# ACCESSIBILITY ASSESSMENT

167588.24R000-005.303

## **ADA TITLE II ASSESSMENT**

Anderson Stadium  
910 Raleigh Road  
Chapel Hill, North Carolina 27514

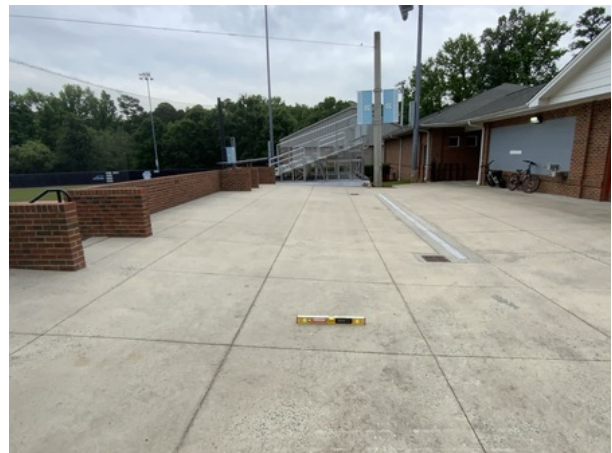
Assembly	Exterior Access Route
Type	Exterior Accessible Route
ADA Standard	403.3
Barrier Detail	The accessible route has cross slopes greater than 1:50 (2%).
Location Description	Accessible Route between Concession Stand & Bleachers
Observed	May 16, 2024 by javondrick.orange@bureauveritas.com

The walkway should be graded to a maximum 1:50 (2%) cross slope. An accessible route has maximum 1:20 (5%) running slope and maximum 1:50 (2%) cross slope. [EXCEPTION: Cross slopes not exceeding 1:48 (2.08%) are permitted.] The clear width of walking surfaces shall be 36" minimum. [EXCEPTION: The clear width shall be permitted to be reduced to 32" minimum for a length of 24" maximum provided that reduced width segments are separated by segments that are 48" long minimum and 36" wide minimum.] Where grading to maximum running slope of 1:20 (5% running slope) is not possible, provide a compliant ramped surface within the walkway with maximum slope 1:12 (8.33%) and maximum ramp run rise of 6" without handrails. If a ramped surface with running slopes greater than 1:20 (5%) and maximum 1:12 (8.33%) rises more than 6", handrails are required. The cost estimate for this barrier removal is based on grading the running slope to maximum 1:20 (5%). The quantity and order of magnitude cost estimate provided for this barrier are limited to the extent of the area identified as non-compliant. Additional costs that may be associated with removal of the barrier are not included.

Photos for Barrier ID: AX468768

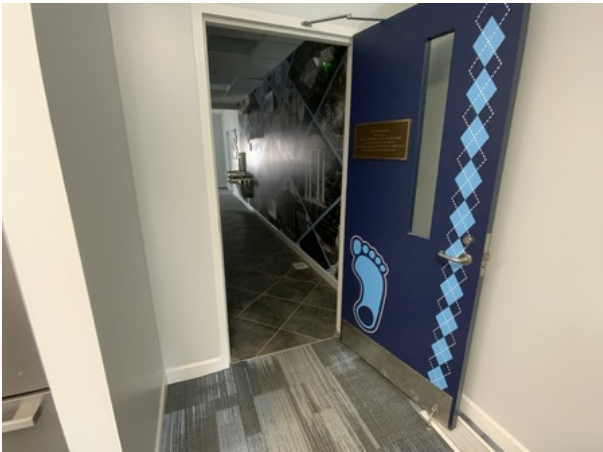
Assembly	Interior Access Route
Type	Door
ADA Standard	404.2.4; Table 404.2.4.1
<b>Barrier Detail</b>	
The pull side of the accessible door does not have the required maneuvering clearances.	
Location Description	Team Room
Observed	May 16, 2024 by javondrick.orange@bureauveritas.com
Site Conditions	For an approach from the front on the pull side the side clearance is 16".

Redesign to provide the required maneuvering clearance at the pull side of the door. The required depth of the maneuvering clearance is 60" minimum. The required side clearance is 18" minimum on the latch side of the door. Maneuvering clearance shall extend the full width of the doorway and the required latch side clearance. Floor or ground space within the required maneuvering clearance shall be maximum 1:48 (2.08%) slope. Changes in level are not permitted.

Photos for Barrier ID: AX468729

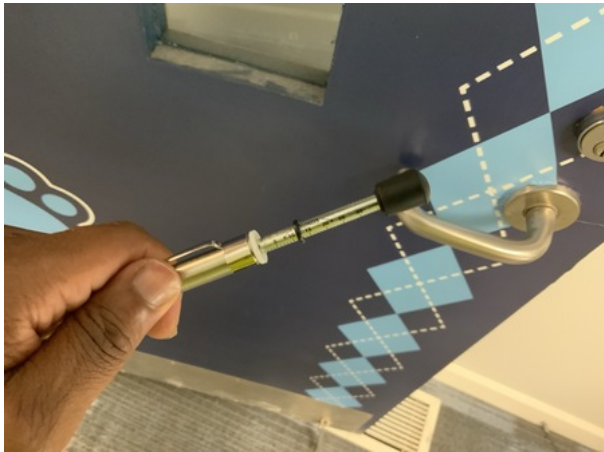
Assembly	Interior Access Route
Type	Door
ADA Standard	404.2.9
Barrier Detail	
The opening force required to open the accessible, hinged, non-fire door is more than 5 pounds.	
Location Description	Team Room
Observed	May 16, 2024 by javondrick.orange@bureauveritas.com
Site Conditions	The door requires 12 pounds of pressure to operate.

Adjust the closer or replace with a door that requires no more than 5 pounds of force for pushing or pulling the door open. This barrier must be removed in conjunction with barrier ID 468731. The force at the latch, the force to set the door in motion, and the force to fully open the door shall be maximum 5 pounds. These forces do not apply to the force required to retract latch bolts or disengage other devices that hold the door or gate in a closed position.

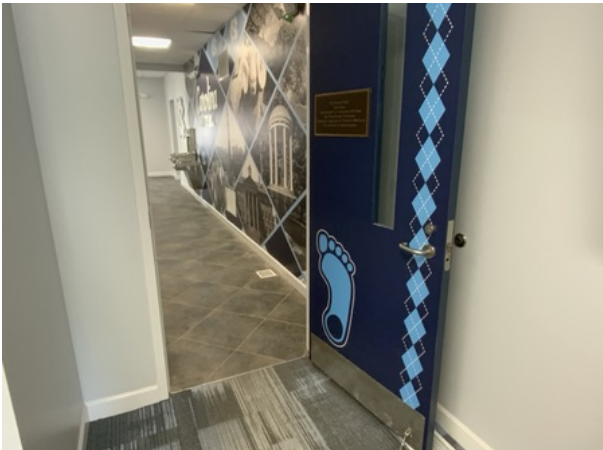
Location Description	Team Room
Observed	May 16, 2024 by javondrick.orange@bureauveritas.com

The closing speed is 2.24 from 90 degrees to a position 12 degrees from latch.

Adjust closer or remove and replace closer to ensure that the door has a closure time of at least 5 seconds within 12 degrees of the latch. This barrier must be removed in conjunction with barrier ID 468730. The cost of this barrier removal is covered under ID 468730 and therefore, the cost of this ID is shown as \$0. Door closers and gate closers shall be adjusted so that from an open position of 90 degrees, the time required to move the door to a position of 12 degrees from the latch is 5 seconds minimum.

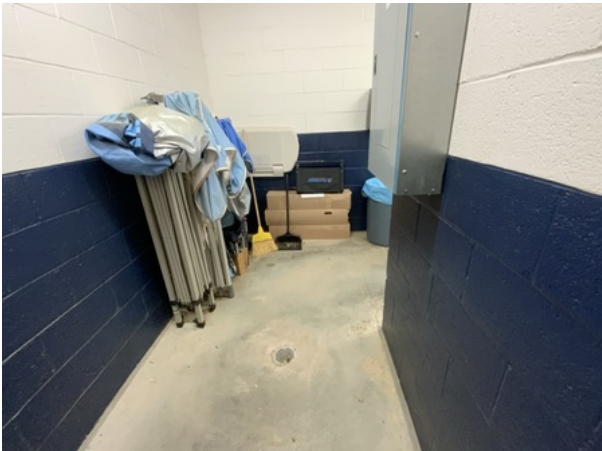
The breaker box protrudes 6" into the circulation path at 43 3/4" above the floor.

Horizontal Protrusion Dimension	6"
---------------------------------	----

Provide a restroom circulation path which does not have objects protruding more than 4" from wall in the space between 27" and 80" height above finish floor.

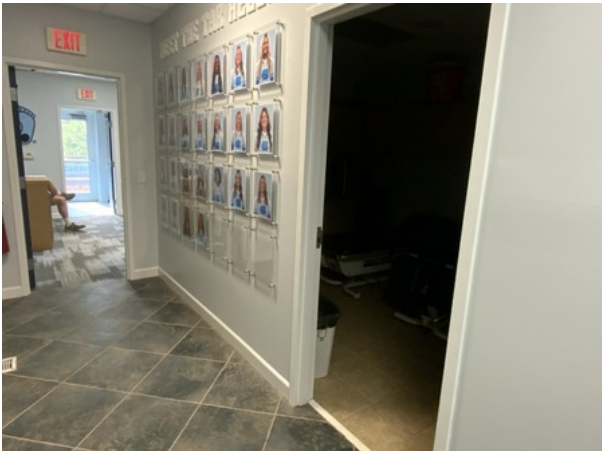
Assembly	Interior Access Route
Type	Signage
ADA Standard	216.2, 703.2; 703.3; 703.5

The interior signage does not have compliant visual and tactile characters, with raised or indented characters or symbols.

Location Description	Rooms Throughout Building
Observed	May 16, 2024 by javondrick.orange@bureauveritas.com
Site Conditions	Signage is not provided on the latch side of the doors.

Remove and replace signage with compliant signage. Raised characters shall be compliant and shall be duplicated in Braille. Raised characters shall be as follows: Depth: Raised characters shall be 1/32" minimum above their background. Case: Characters shall be uppercase. Style: Characters shall be sans serif. Characters shall not be italic, oblique, script, highly decorative, or of other unusual forms. Character Proportions: Characters shall be selected from fonts where the width of the uppercase letter "O" is 55 % minimum and 110 % maximum of the height of the uppercase letter "I". Character Height: Character height measured vertically from the baseline of the character shall be 5/8" minimum and 2" maximum based on the height of the uppercase letter "I". [EXCEPTION: Where separate raised and visual characters with the same information are provided, raised character height shall be permitted to be 1/2" minimum.] Tactile characters on signs shall be located 48" minimum above the finish floor or ground surface, measured from the baseline of the lowest tactile character and 60" maximum above the finish floor or ground surface, measured from the baseline of the highest tactile character. Where a tactile sign is provided at a door, the sign shall be located alongside the door at the latch side. Where a tactile sign is provided at double doors with one active leaf, the sign shall be located on the inactive leaf. Where a tactile sign is provided at double doors with two active leafs, the sign shall be located to the right of the right hand door. Where there is no wall space at the latch side of a single door or at the right side of double doors, signs shall be located on the nearest adjacent wall. Signs containing tactile characters shall be located so that a clear floor space of 18" minimum by 18" minimum, centered on the tactile characters, is provided beyond the arc of any door swing between the closed position and 45 degree open position. [EXCEPTION: Signs with tactile characters shall be permitted on the push side of doors with closers and without hold-open devices.]

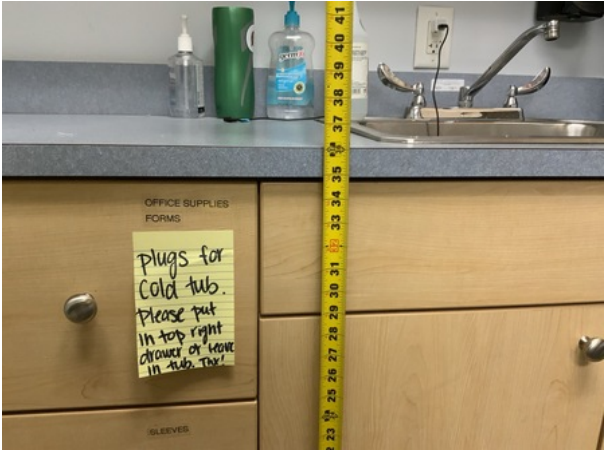
Assembly	Interior Access Route	
Type	Door	
ADA Standard	404.2.10	
Barrier Detail		
The surface of the swinging door within 10 inches of the finish floor or ground for the full width of the door on the push side is not smooth.		
Location Description	Team Room	
Observed	May 16, 2024 by javondrick.orange@bureauveritas.com	
Site Conditions	The doorstep is within the 10" smooth surface on the push side of the door.	
Resolution		
Modify or replace the door to provide a smooth surface on the door within 10 inches of the finish floor or ground for the full width of the door on the push side. Parts creating horizontal or vertical joints in these surfaces shall be within 1/16 inch of the same plane as the other and be free of sharp or abrasive edges. Cavities created by added kick plates shall be capped.Swinging door and gate surfaces within 10 inches of the finish floor or ground measured vertically shall have a smooth surface on the push side extending the full width of the door or gate. Parts creating horizontal or vertical joints in these surfaces shall be within 1/16 inch of the same plane as the other. Cavities created by added kick plates shall be capped. [EXCEPTIONS: 1. Sliding doors shall not be required to comply. 2. Tempered glass doors without stiles and having a bottom rail or shoe with the top leading edge tapered at 60 degrees minimum from the horizontal shall not be required to meet the 10 inch bottom smooth surface height requirement. 3. Doors and gates that do not extend to within 10 inches of the finish floor or ground shall not be required to comply. 4. Existing doors and gates without smooth surfaces within 10 inches of the finish floor or ground shall not be required to provide smooth surfaces provided that if added kick plates are installed, cavities created by such kick plates are capped.]

**Photos for Barrier ID: AX468722**

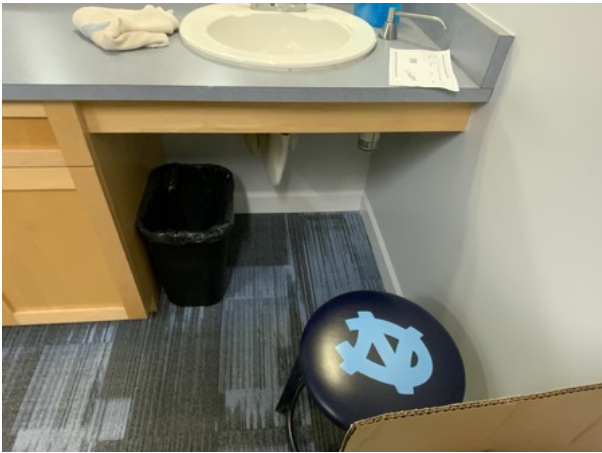
Assembly	Restroom
Type	Restroom/Bathroom - Lavatory
ADA Standard	606.2; 305
Barrier Detail	
The lavatory does not have the required clear floor space of minimum 30" by minimum 48".	
Location Description	Head Coach Office - Restroom
Observed	May 16, 2024 by javondrick.orange@bureauveritas.com
Site Conditions	The lavatory clear floor space is obstructed by furniture.

Relocate the furniture to provide minimum 30" by minimum 48" clear floor space positioned for a forward approach to the lavatory. Compliant knee and toe clearance shall be provided. [EXCEPTIONS: 2. A lavatory in a toilet room or bathing facility for a single occupant accessed only through a private office and not for common use or public use shall not be required to provide knee and toe clearance. 3. In residential dwelling units, cabinetry shall be permitted under lavatories and kitchen sinks provided that all of the following conditions are met: (a) the cabinetry can be removed without removal or replacement of the fixture; (b) the finish floor extends under the cabinetry; and (c) the walls behind and surrounding the cabinetry are finished. 4. A knee clearance of 24" minimum above the finish floor or ground shall be permitted at lavatories and sinks used primarily by children 6 through 12 years where the rim or counter surface is 31" maximum above the finish floor or ground. 5. A parallel approach complying with 305 shall be permitted to lavatories and sinks used primarily by children 5 years and younger. 6. The dip of the overflow shall not be considered in determining knee and toe clearances. 7. No more than one bowl of a multi-bowl sink shall be required to provide knee and toe clearance.] Space under an element between 9" and 27" above the finish floor or ground shall be considered knee clearance and shall comply. Knee clearance shall extend 25" maximum under an element at 9" above the finish floor or ground. Floor or ground surfaces of a clear floor or ground space shall comply. Changes in level are not permitted. [EXCEPTION: Slopes not steeper than 1:48 shall be permitted.] The clear floor or ground space shall be 30" minimum by 48" minimum. One full unobstructed side of the clear floor or ground space shall adjoin an accessible route or adjoin another clear floor or ground space. Where a clear floor or ground space is located in an alcove or otherwise confined on all or part of three sides, additional maneuvering clearance shall be provided. Alcoves shall be 36" wide minimum where the depth exceeds 24". Alcoves shall be 60" wide minimum where the depth exceeds 15".

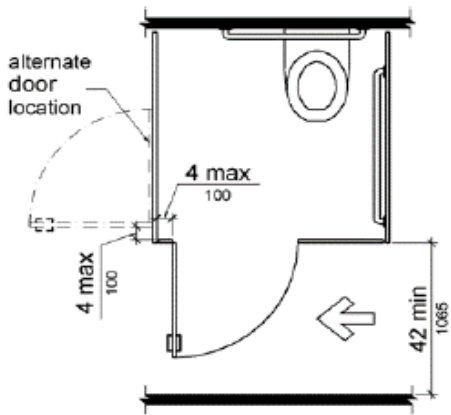
Assembly	Restroom
Type	Restroom/Bathroom - Toilet Stall
ADA Standard	309, 404.2.7, 604.8.1.2
Barrier Detail	The wheelchair stall door is not compliant.
Location Description	Head Coach Office - Restroom
Observed	May 16, 2024 by javondrick.orange@bureauveritas.com

The wheelchair stall door is not self closing and a door pull is not provided on the interior side.

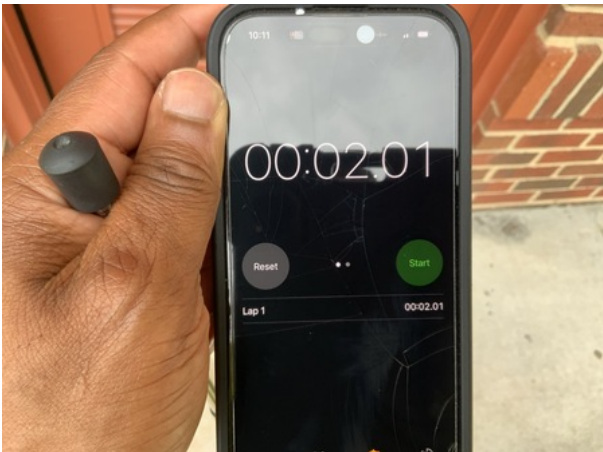
Location Description	Men's Restroom
Observed	May 16, 2024 by javondrick.orange@bureauveritas.com

The closing speed is 2.01 from 90 degrees to a position 12 degrees from latch.

Adjust closer or remove and replace closer to ensure that the door has a closure time of at least 5 seconds within 12 degrees of the latch. This barrier must be removed in conjunction with barrier ID 468750. The cost of this barrier removal is covered under ID 468750 and therefore, the cost of this ID is shown as \$0. Door closers and gate closers shall be adjusted so that from an open position of 90 degrees, the time required to move the door to a position of 12 degrees from the latch is 5 seconds minimum.

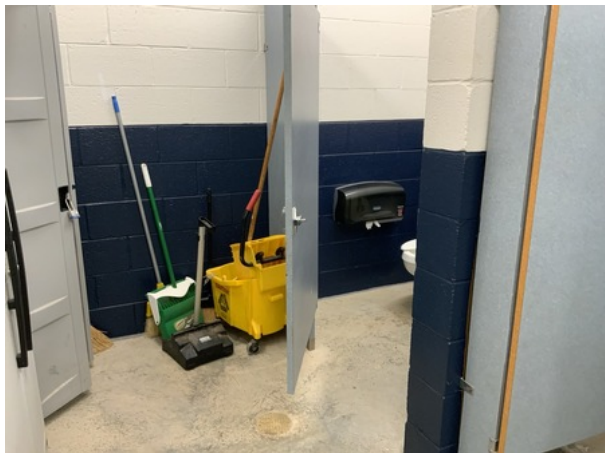
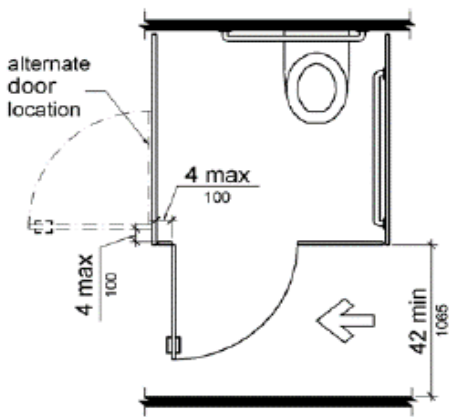
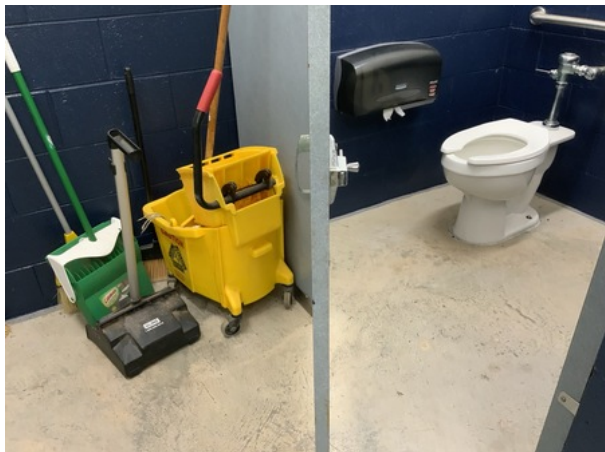
Assembly	Restroom
Type	Restroom/Bathroom - Toilet Stall
ADA Standard	309, 404.2.7, 604.8.1.2
Barrier Detail	The wheelchair stall door is not compliant.
Location Description	Men's Restroom
Observed	May 16, 2024 by javondrick.orange@bureauveritas.com

The wheelchair stall door is not self closing and a door pull is not provided on the interior side.

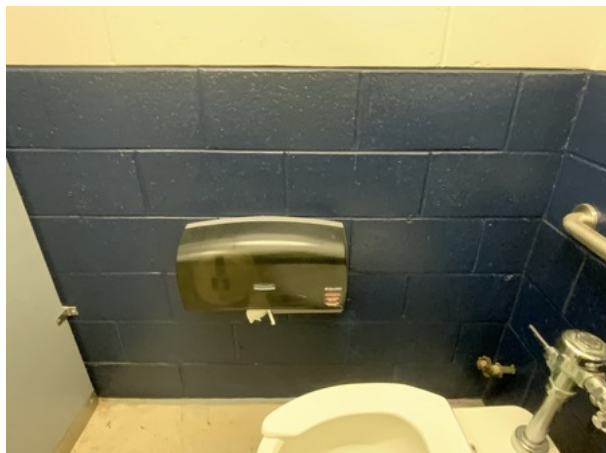
Assembly	Restroom
Type	Restroom/Bathroom - Toilet Stall
ADA Standard	604.5.1; 604.8.1.5
Barrier Detail	The side grab bar is not compliant in the wheelchair stall.
Location Description	Men's Restroom
Observed	May 16, 2024 by javondrick.orange@bureauveritas.com
Site Conditions	A side grab bar is not provided in the wheelchair stall.

Remove and install a compliant side grab bar in the wheelchair stall. The top of the gripping surface of horizontal grab bars shall be located minimum 33" and maximum 36" above the finished floor. The side wall grab bar shall be 42" long minimum, located 12" maximum from the rear wall and extending 54" minimum from the rear wall. A continuous grab bar is allowable in lieu of two grab bars (one side and one rear). .[ADVISORY: It is advisable, but not required, to use the specifications for children where children are the primary users of the restroom. Guidance in applying the specifications for children according to the age group served reflects the differences in the size, stature, and reach ranges of children ages 3 to 12. The specifications chosen should correspond to the age of the primary user group. The specifications of one age group should be applied consistently in the installation of a water closet and related elements. Water Closet Centerline: Ages 3 and 4- 12"; Ages 5 through 8- 12" to 15"; Ages 9 through 12- 15" to 18". Toilet Seat Height: Ages 3 and 4- 11" to 12"; Ages 5 through 8- 12" to 15"; Ages 9 through 12- 15" to 17". Grab Bar Height: Ages 3 and 4- 18" to 20"; Ages 5 through 8- 20" to 25"; Ages 9 through 12- 25" to 27"; Dispenser Height: Ages 3 and 4- 14"; Ages 5 through 8- 14" to 17"; Ages 9 through 12- 17" to 19"].

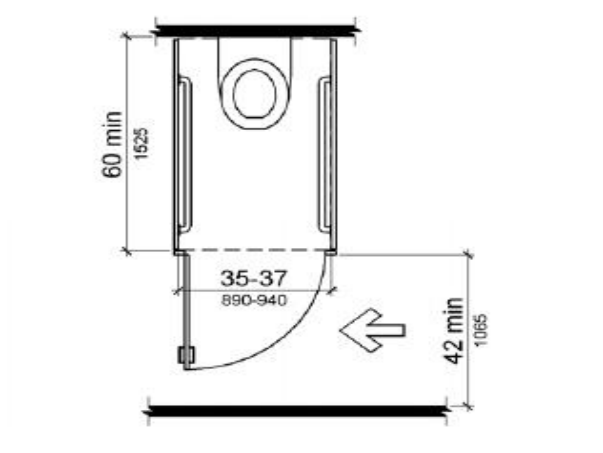
The ambulatory stall size is not compliant, or an ambulatory stall is not provided.

Location Description	Men's Restroom
Observed	May 16, 2024 by javondrick.orange@bureauveritas.com

An ambulatory stall is not provided where there are 3 toilet compartments and 4 urinals.

Provide a compliant ambulatory stall, where six or more toilet compartments are provided or where the combination of urinals and water closets totals six or more fixtures. An ambulatory stall is minimum 60" deep and the width is minimum 35" and maximum 37". Grab bars shall be provided on both sides of the compartment. The side grab bars shall be 33" minimum to 36" maximum above finish floor to the top of the gripping surface, except in children's (ages 3-12) water closets where horizontal grab bars shall be 18" minimum and 27" maximum above the finish floor to the top of the gripping surface. Horizontal grab bars should be installed at a consistent height. The side wall grab bars shall be 42" long minimum, located 12" maximum from the rear wall and extending 54" minimum from the rear wall. The centerline of the toilet shall be minimum 17" to maximum 19" from the side wall. Toilet compartment doors for ambulatory stalls shall be minimum 32" wide when open 90 degrees and have minimum 80" high clearance. If the approach is to the latch side of the compartment door, clearance between the exterior side of the door of the compartment and any obstruction shall be 42" minimum. The door shall be self-closing. A compliant door pull shall be placed on both sides of the door near the latch. Toilet compartment doors shall not swing into the minimum required compartment area. [ADVISORY: It is advisable, but not required, to use the specifications for children where children are the primary users of the restroom. Guidance in applying the specifications for children according to the age group served reflects the differences in the size, stature, and reach ranges of children ages 3 to 12. The specifications chosen should correspond to the age of the primary user group. The specifications of one age group should be applied consistently in the installation of a water closet and related elements. Water Closet Centerline: Ages 3 and 4- 12"; Ages 5 through 8- 12" to 15"; Ages 9 through 12- 15" to 18". Toilet Seat Height: Ages 3 and 4- 11" to 12"; Ages 5 through 8- 12" to 15"; Ages 9 through 12- 15" to 17". Grab Bar Height: Ages 3 and 4- 18" to 20"; Ages 5 through 8- 20" to 25"; Ages 9 through 12- 25" to 27"; Dispenser Height: Ages 3 and 4- 14"; Ages 5 through 8- 14" to 17"; Ages 9 through 12- 17" to 19".]

**Photos for Barrier ID: AX468748**

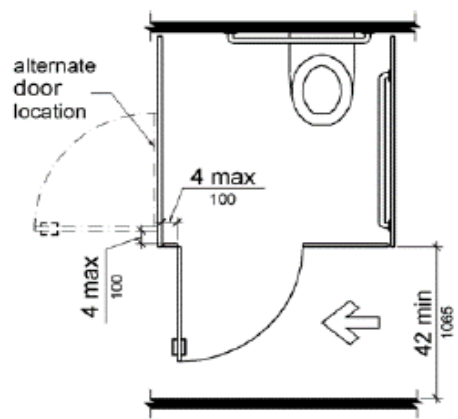
Assembly	Restroom
Type	Restroom/Bathroom - Toilet Stall
ADA Standard	309, 404.2.7, 604.8.1.2
Barrier Detail	The wheelchair stall door is not compliant.
Location Description	Team Locker Room
Observed	May 16, 2024 by javondrick.orange@bureauveritas.com

The wheelchair stall door is not self closing and a door pull is not provided on the interior side.

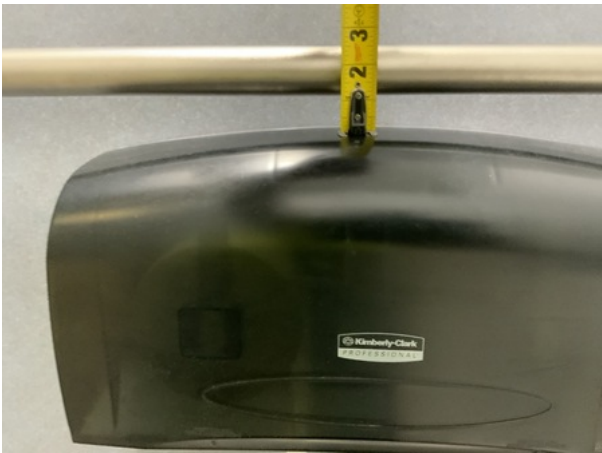
Location Description	Team Locker Room
Observed	May 16, 2024 by javondrick.orange@bureauveritas.com

The space between the bottom of the side wall grab bar and top of the toilet paper dispenser is 1 1/8".

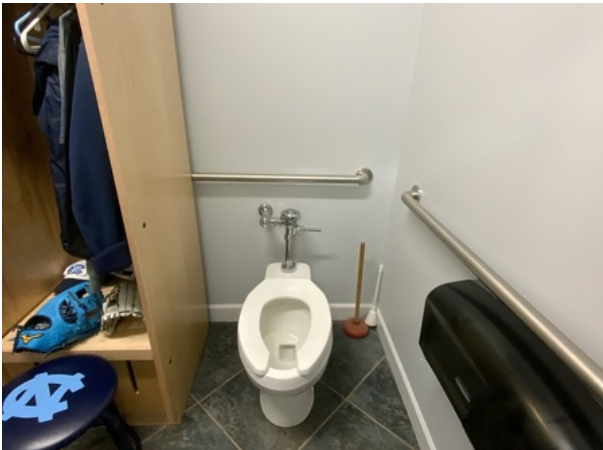
Location Description	Unisex Restroom
Observed	May 16, 2024 by javondrick.orange@bureauveritas.com

The clear space at the water closet is 37 1/4" measured perpendicular from the side wall to the locker.

Relocate locker to provide compliant water closet clearance. Clearance around a water closet shall be 60" minimum measured perpendicular from the side wall and 56" minimum measured perpendicular from the rear wall. The water closet shall be positioned with a wall or partition to the rear and to one side. The centerline of the water closet shall be 16" minimum to 18" maximum from the side wall or partition, except that the water closet shall be 17" minimum and 19" maximum from the side wall or partition in the ambulatory accessible toilet compartment. Water closets shall be arranged for a left-hand or right-hand approach. The required clearance around the water closet shall be permitted to overlap the water closet, associated grab bars, dispensers, sanitary napkin disposal units, coat hooks, shelves, accessible routes, clear floor space and clearances required at other fixtures, and the turning space. No other fixtures or obstructions, such as lavatories, shall be located within the required water closet clearance. [ADVISORY: It is advisable, but not required, to use the specifications for children where children are the primary users of the restroom. Guidance in applying the specifications for children according to the age group served reflects the differences in the size, stature, and reach ranges of children ages 3 to 12. The specifications chosen should correspond to the age of the primary user group. The specifications of one age group should be applied consistently in the installation of a water closet and related elements. Water Closet Centerline: Ages 3 and 4- 12"; Ages 5 through 8- 12" to 15"; Ages 9 through 12- 15" to 18". Toilet Seat Height: Ages 3 and 4- 11" to 12"; Ages 5 through 8- 12" to 15"; Ages 9 through 12- 15" to 17". Grab Bar Height: Ages 3 and 4- 18" to 20"; Ages 5 through 8- 20" to 25"; Ages 9 through 12- 25" to 27"; Dispenser Height: Ages 3 and 4- 14"; Ages 5 through 8- 14" to 17"; Ages 9 through 12- 17" to 19"].

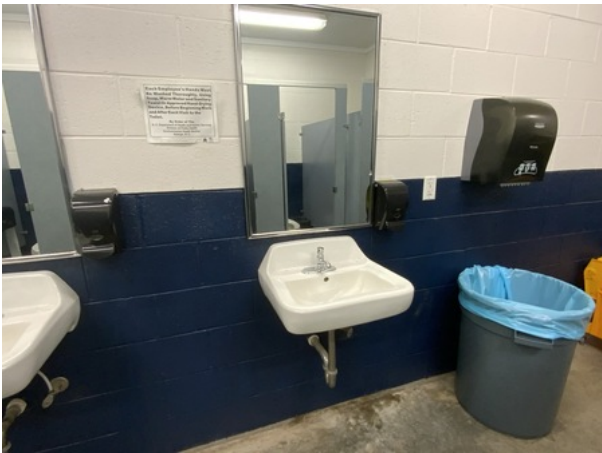
The mirror is mounted higher than 40" above finish floor to the bottom of the reflective surface, where it is installed above a lavatory or counter.

Location Description	Women's Restroom
Observed	May 16, 2024 by javondrick.orange@bureauveritas.com
Site Conditions	The bottom of the reflective surface of the mirror is 40 1/4" above the floor.

Remove and lower the mirror to a compliant height. Where mirrors are provided, at least one shall comply. Mirrors located above lavatories or countertops shall be installed with the bottom edge of the reflecting surface 40" maximum above the finish floor or ground. Mirrors not located above lavatories or countertops shall be installed with the bottom edge of the reflecting surface 35" maximum above the finish floor or ground. [ADVISORY: A single full-length mirror can accommodate a greater number of people, including children. In order for mirrors to be usable by people who are ambulatory and people who use wheelchairs, the top edge of mirrors should be 74" minimum from the floor or ground.]
